ADDENDUM NO.: Three (3)

RE: BID PROPOSAL NO.: 2285-01276

SUBJECT: New Fifth District Police Station

New Fifth District Police Station
Hegedus Project No. 0713-O-5
Project No. NPD006
FEMA PW # 08486

S-1.0 – STRUCTURAL NOTES, revision date 04-18-12 (revisions clouded) |

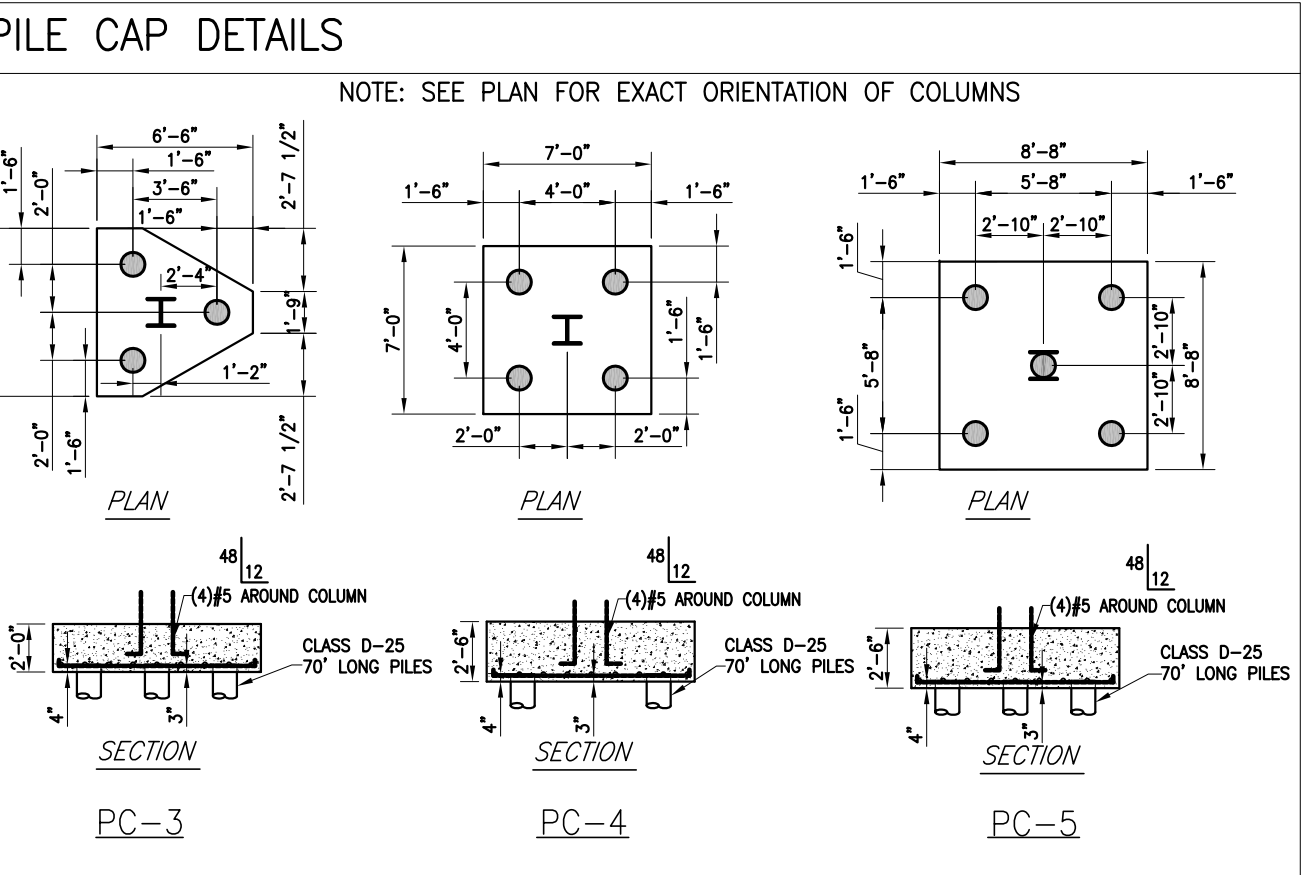
- PILES SHALL BE CLASS B AND CLASS 5 TREATED TIMBER POLES AS INDICATED AND CONFORMING TO ASTM D-25.
- DRIVE PILING WITH A STEAM HAMMER SEE SPECIFICATIONS FOR DRIVING EQUIPMENT REQUIREMENT. DISCONTINUE DRIVING IF BLOWS COUNTS ARE EXCEEDED. SEE SPECIFICATIONS.

- PRE-PUNCHING OR PRE-DRILLING SHOULD NOT BE NECESSARY BASED ON SOILS DATA. HOWEVER, IF SURFACE VIBRATIONS EXCEED ALLOWABLE TOLERANCES (0.25 IN./SEC.), THIS MAY BE NECESSARY. IF PRE-PUNCHING OR PRE-DRILLING IS REQUIRED, THE PILOT HOLE MADE MAY NOT EXCEED 5 FEET DEEP AND 75% OF THE PILE'S BUTT DIAMETER. THE NECESSITY FOR PRE-DRILLING WILL BE ASSESSED IN THE TEST PILE PROGRAM.
